### **NOTICE OF VIOLATION**

On July 16, 2024, Energy Safety conducted an inspection of Southern California Edison Company's WMP initiatives in the vicinity of the city of Yorba Linda, California. The inspection report is enclosed herewith. Energy Safety found the following violation(s):

## **INSPECTION REPORT**

Electrical Corporation:	Southern California Edison Company				
Report Number:	CADSCE_SIS_20240716_0938				
Inspector:	Samuel Isaiah				
WMP Year Inspected:	2023				
Quarterly Data Report (QDR) Referenced:	Quarter 4 (Q4)				
Inspection Selection:	Energy Safety viewed the contents of the Q4 QDR and performed an analysis that resulted in the selection of				
	the WMP initiatives and locations referenced in this report.				
Relevant WMP Initiative(s):	8.1.2.1.1 Covered Conductor				
Date of inspection:	July 16, 2024				
City and/or County of Inspection:	Yorba Linda, Orange County				
Inspection Purpose:	Assess the accuracy of Southern California Edison Company's QDR data, completeness of its work, compliance				
	with WMP requirements, and compliance with its protocols.

**Item1IA1Img1**: No Covered Conductor on this pole

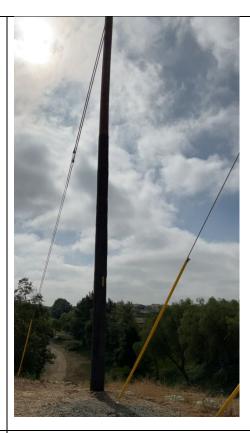
On pole ID 4724574E, Grid Hardening ID TD1817317-4724574E, at 17001-17199 Camino Cabrillo, Yorba Linda, California, 92886, USA, 33.91052008703597, -117.83700945683373, the inspector observed that no covered conductor was present. The inspector's observation is documented in Violation 1 photographs, which are attachments to this report. Photo numbers Item1Glmg1, Item1Glmg2, Item1IA1Img1, Item1IA1Img2 depict that no covered conductor was installed at the location.

- 1. Southern California Edison Company's 2023 WMP Covered Conductor (8.1.2.1.1) work was identified as complete at this location.
- 2. Covered Conductor (8.1.2.1.1) was not installed.
